**APPLICATION FOR FINAL SUBDIVISION APPROVAL
470 THOMPSON STREET-2 LOT RESUBDIVISION
MEETING DATE : MAY 21, 2024**

The Engineering Division has reviewed plans for the proposed 470 Thompson Street Subdivision prepared by Oswald Blint Surveying revised through January 6, 2023 and by Inga Consulting Engineers revised through May 30, 2023 and offers the following comments:

The Engineering Division has reviewed plans for the proposed 470 Thompson Street Subdivision prepared by Megson, Heagle, and Friend Civil Engineers and Land Surveyors LLC last revised April 4, 2024 and offers the following comments:

#470 THOMPSON STREET SUBDIVISION

SITE DEVELOPMENT PLAN
470 THOMPSON STREET SUBDIVISION
PREPARED FOR
CHRIS SWITALSKI
GLASTONBURY, CONN

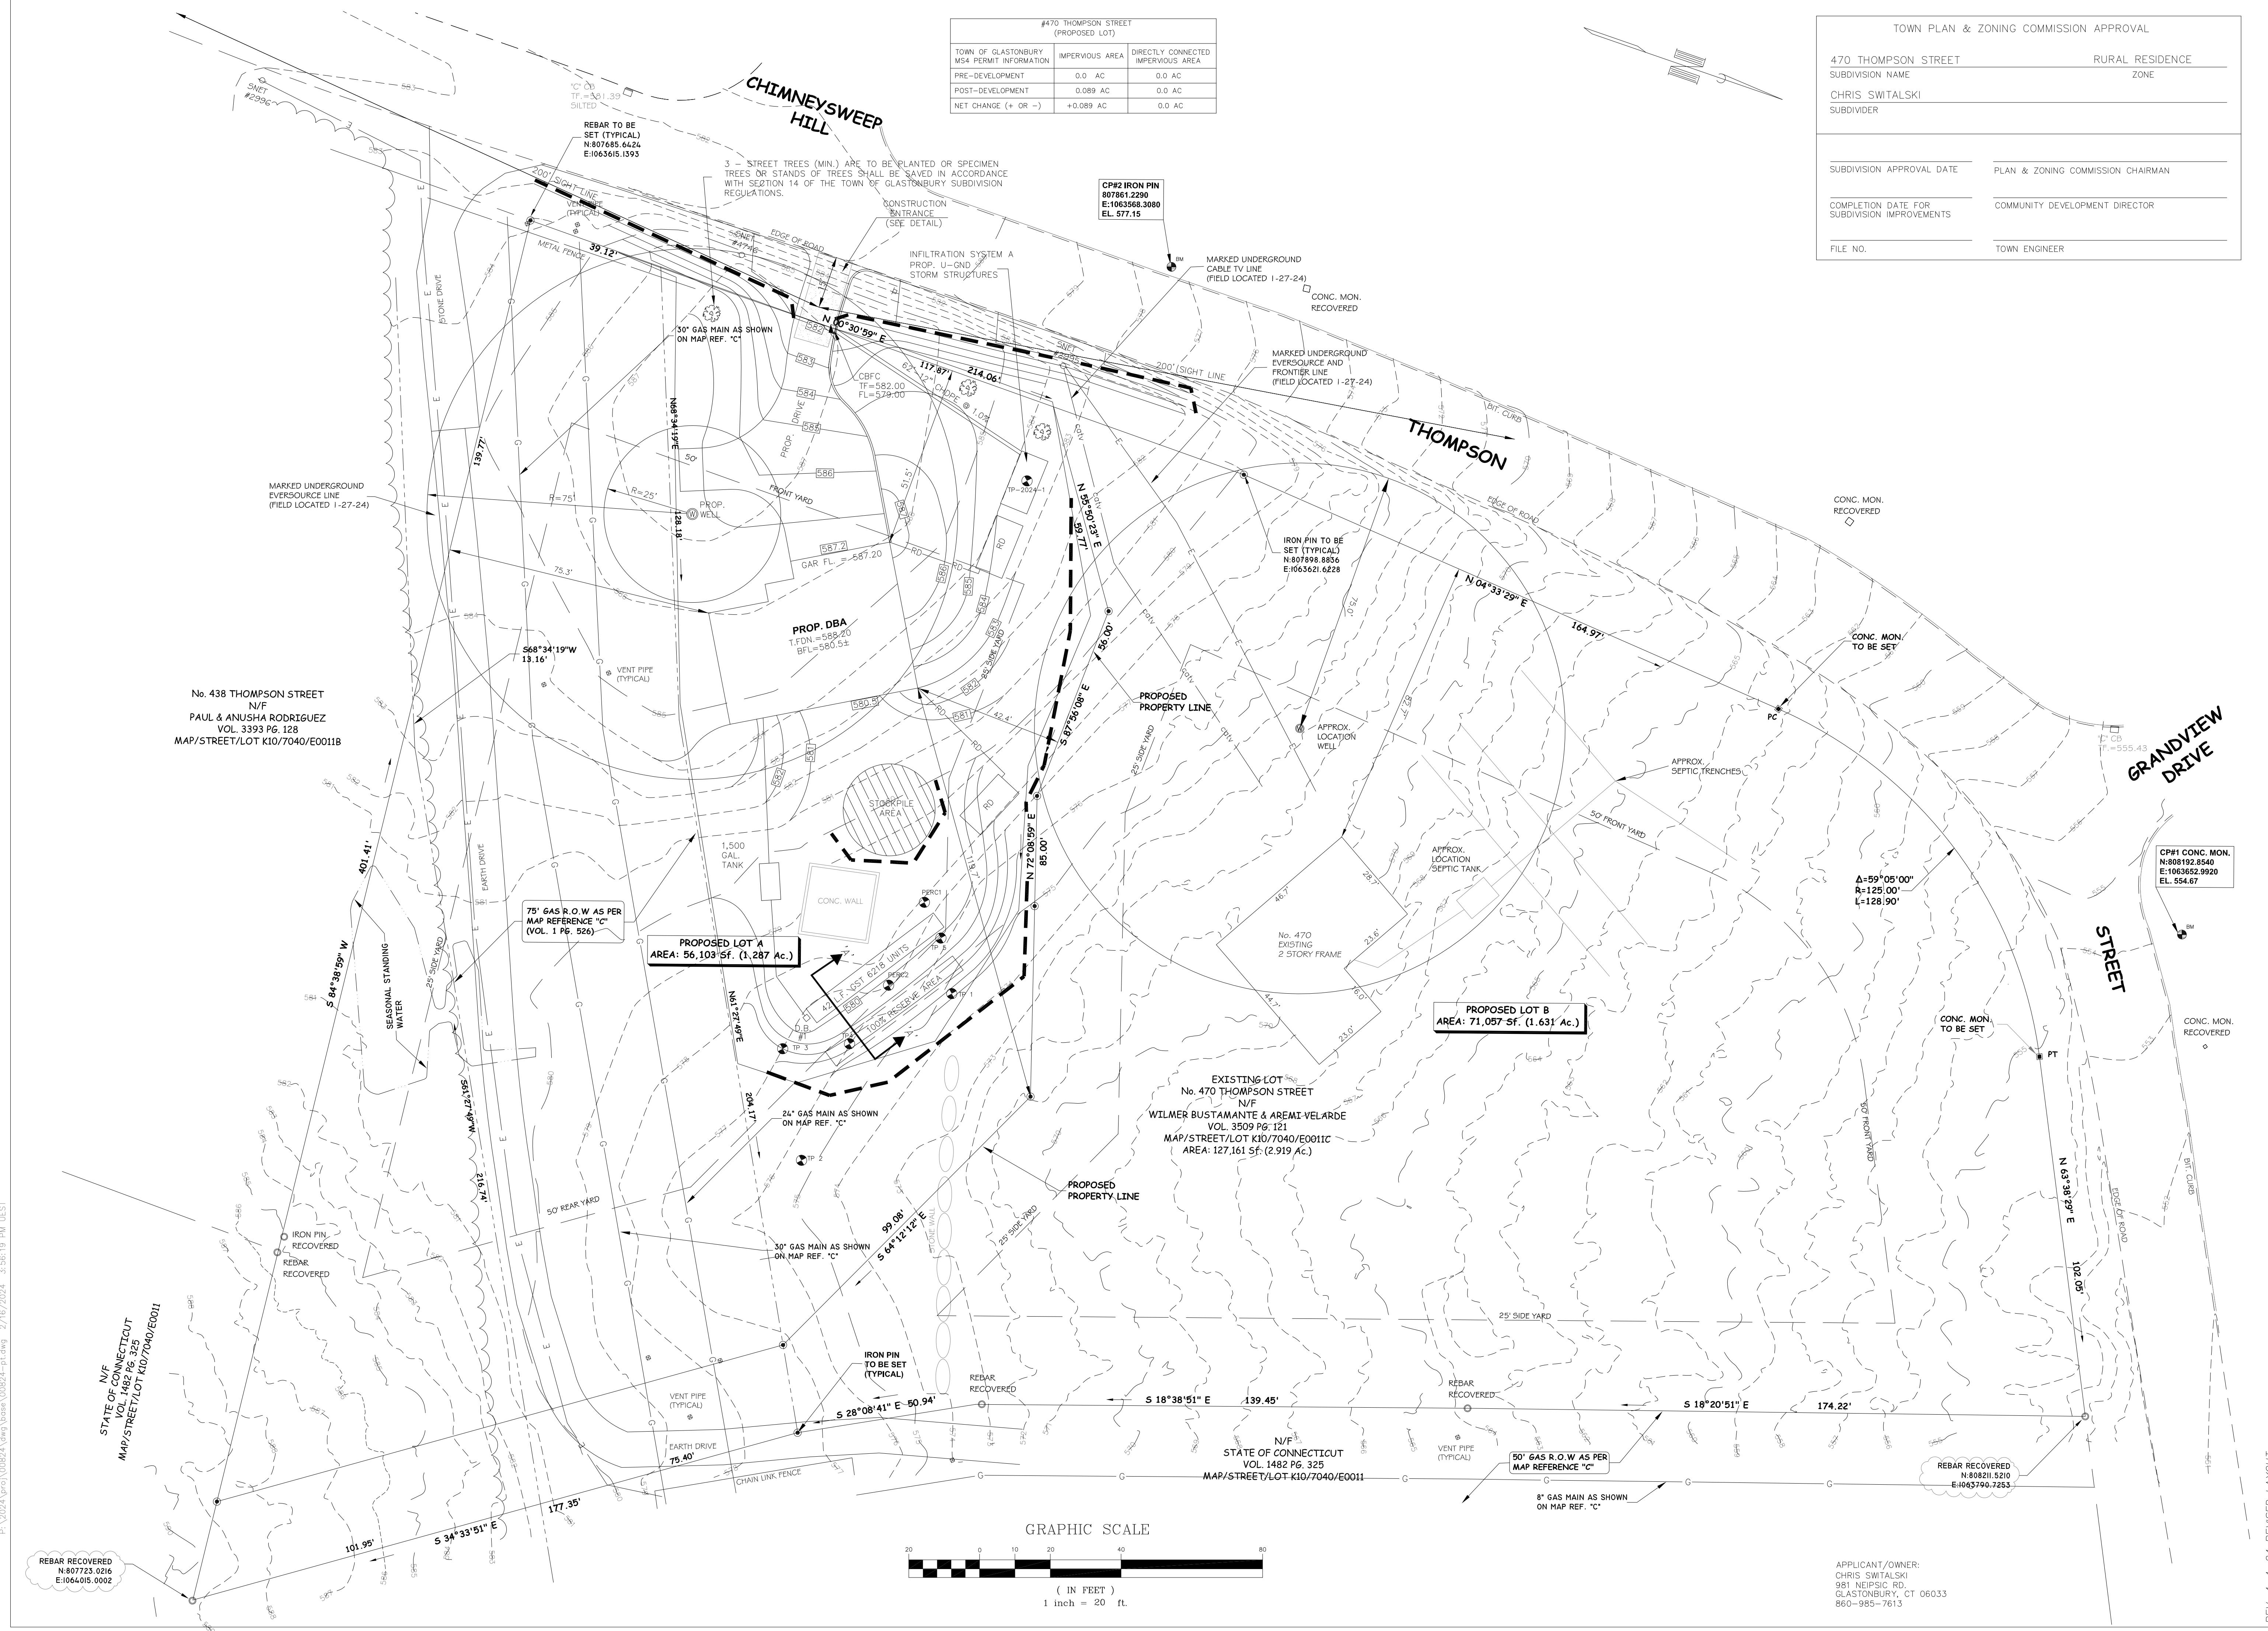
1. Water quality volume computations provided on the plans confirm that the proposed infiltration systems are consistent with Town standards.
2. Elevations for the proposed infiltration systems need to be labeled on the plans and details including bottom and top of system elevation, bottom of stone elevation, etc. Flow lines for storm drain pipes entering these systems should also be labeled on the plans. Infiltration systems also require a riser to grade to provide a means of inspecting the system to confirm function.

4. The limits of proposed bituminous curbing on the north side of the driveway should be labeled on the site plan. Driveway grading should be adjusted to direct the majority of the driveway run-off into the proposed catch basin.

5. Provide additional spot grades at all house and driveway corners to clarify grading intent.
6. A drainage swale should be added to the site grading along the northerly property line to direct stormwater run-off from the proposed lot away from the existing house on Lot B.

7. An address for the newly created lot shall be obtained from the Engineering Division and added to plan prior to recording of final mylars.
8. Provide a legend for all line types used on the site plan including proposed silt fence.
